SITE VISIT REPORT

Report No. 1

**Re: Rehabilitation of 30 m Sand Dome
Manvers Works Yard
The City of Kawartha Lakes**

DESIGNED:	J.K.
DRAWN:	J.W.
PROJECT ENGINEER:	J.K.
APPROVED:	J.K.
DRAWING No.	17-870-4

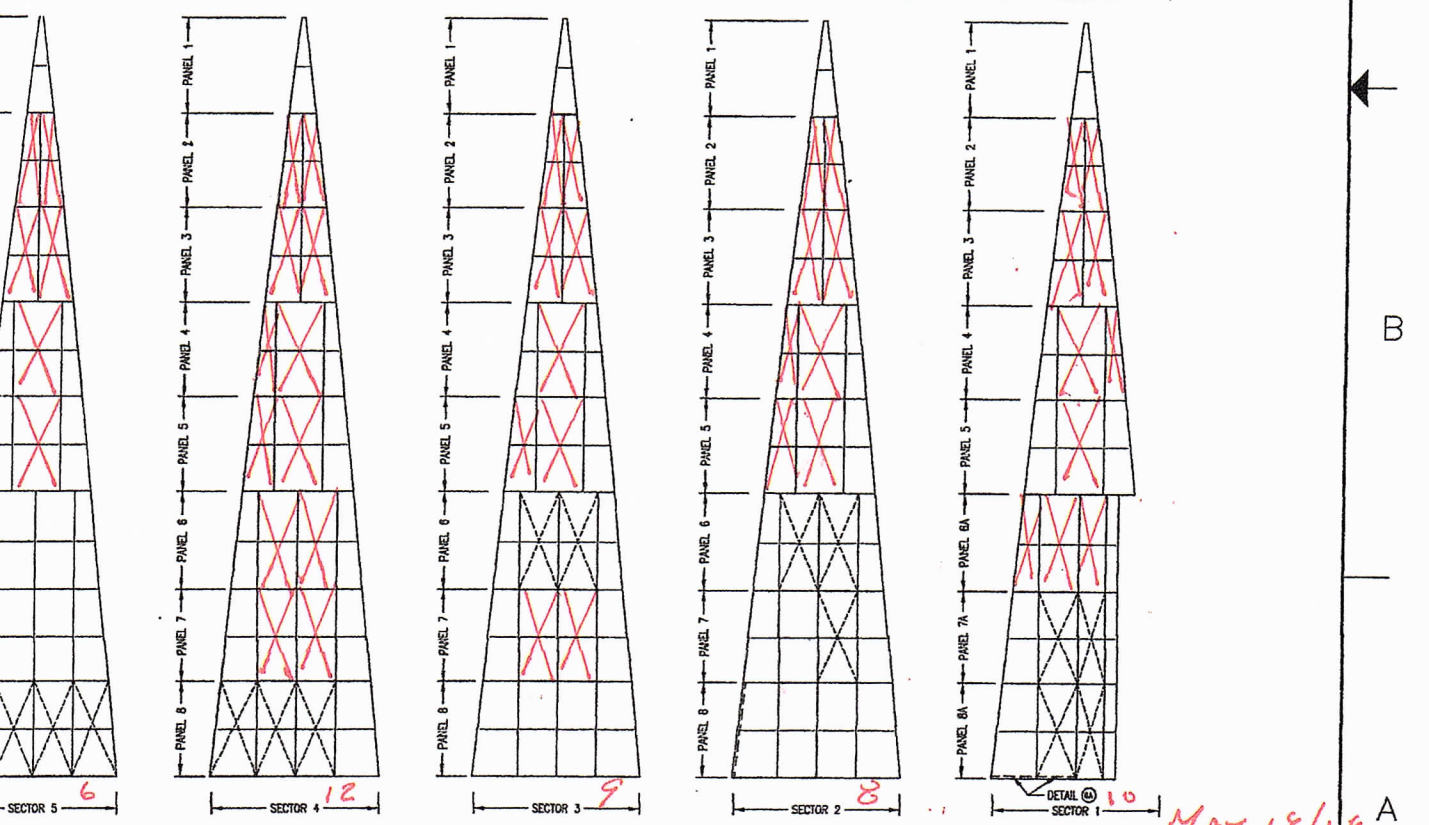
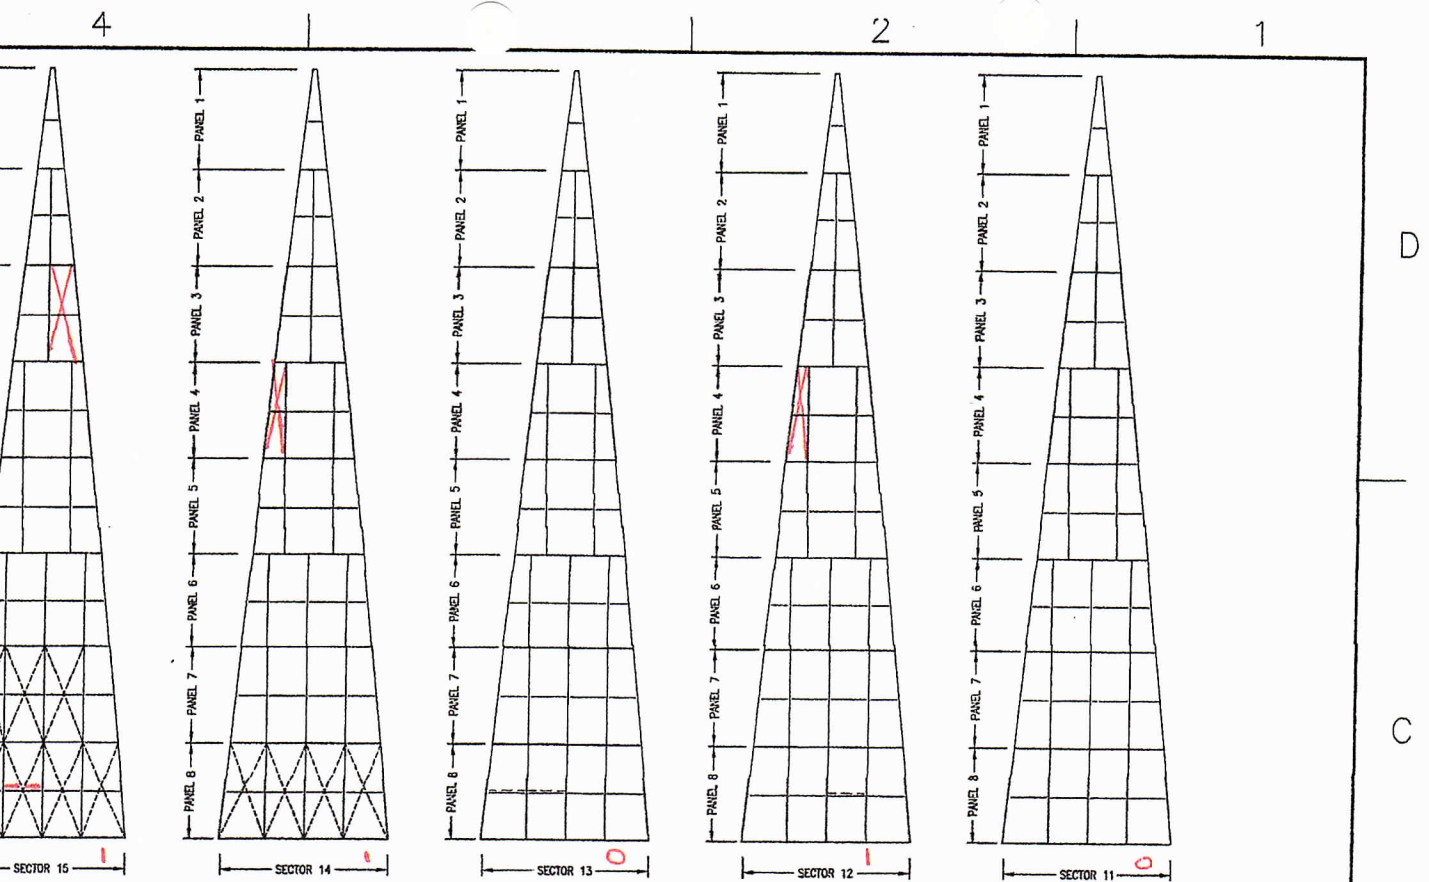
All of the above meet or exceed the requirements of the material specifications within the Special Provisions.
6. Attached is Drawing No. 17-870-4 copied as two halves and marked up in colour. Changes in the scope of work are shown in red thereon. All such additional work is to be done on the Contract's Unit Price basis.
7. Further to No. 6 the changes to the plywood repairs to be undertaken per the Unit Price provisions of the Contract are as follows.

Sector 1 Panel No. 2.....	2 sheets
Sector 1 Panel No. 3.....	2
Sector 1 Panel No. 4.....	2
Sector 1 Panel No. 5.....	1
Sector 1 Panel No. 6.....	3
Sector 2 Panel No. 2.....	2
Sector 2 Panel No. 3.....	2
Sector 2 Panel No. 4.....	2
Sector 2 Panel No. 5.....	2
Sector 3 Panel No. 2.....	2
Sector 3 Panel No. 3.....	2
Sector 3 Panel No. 4.....	1
Sector 3 Panel No. 5.....	2
Sector 3 Panel No. 7.....	2

Sector 4 Panel No. 2.....	2
Sector 4 Panel No. 3.....	2
Sector 4 Panel No. 4.....	2
Sector 4 Panel No. 5.....	2
Sector 4 Panel No. 6.....	2
Sector 4 Panel No. 7.....	2
Sector 5 Panel No. 2.....	2
Sector 5 Panel No. 3.....	2
Sector 5 Panel No. 4.....	1
Sector 5 Panel No. 6.....	1
Sector 6 Panel No. 4.....	1
Sector 6 Panel No. 6.....	1
Sector 10 @ fan dormer.....	3
Sector 12 Panel No. 4.....	1
Sector 14 Panel No. 4.....	1
Sector 15 Panel No. 3.....	1
Sector 16 Panel No. 3.....	1
Sector 17 Panel No. 2.....	2
Sector 18 Panel No. 2.....	2
Sector 19 Panel No. 2.....	2
Sector 19 Panel No. 3.....	2
Sector 19 Panel No. 4.....	1
Sector 20 Panel No. 2.....	2
Sector 20 Panel No. 3.....	2
Sector 20 Panel No. 4.....	<u>2</u>
TOTAL.....	66 sheets
